Product/Process Change Notice (PCN)

PCN Number: PCN_PeBUFU_20250618 Affected Series: WP-BUFU Affected Part Number: 7461097 ; 7461095 ; 7461147 PCN Date: 2025-03-18 (YYYY-MM-DD) Effective Date: 2025-06-18 (YYYY-MM-DD)	Change Category: ☐ Equipment/Location ☒ General Data ☐ Material ☐ Process ☐ Product Design ☒ Shipping/Packaging ☐ Supplier ☐ Software
Contact: Product Management Phone: +49 (0) 7942 - 945 5001 Fax: +49 (0) 7942 - 945 5179 E-Mail: pcn.eican@we-online.com	Datasheet Change: ☒ Yes ☐ No Attachment: ☐ Yes ☒ No

- Pictures & dimensions

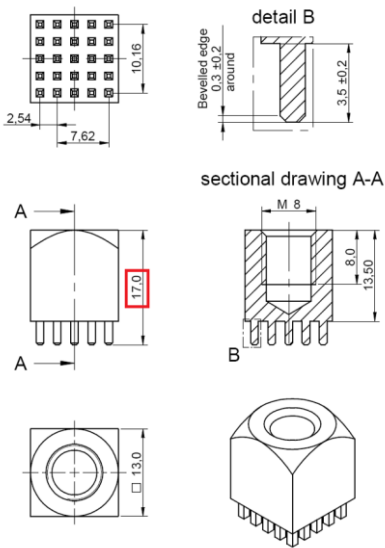
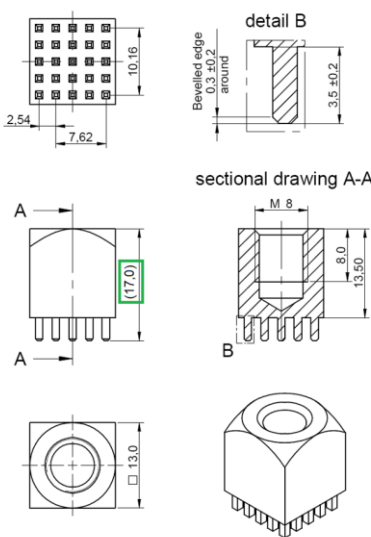
Before Change		After Change	
Carton Case (SPQ)	Shipping Carton (CPQ)	Carton Tray (SPQ)	Shipping Carton (CPQ)

Dimensions (LxWxH):	Dimensions (LxWxH):	Dimensions (LxWxH):	Dimensions (LxWxH):
108.0 x 85.0 x 65.0 mm	300.0 x 200.0 x 115.0 mm	274.0 x 171.0 x 15.0 mm	300.0 x 200.0 x min. 115.0 mm Height varies depending on the component due to two-part carton.
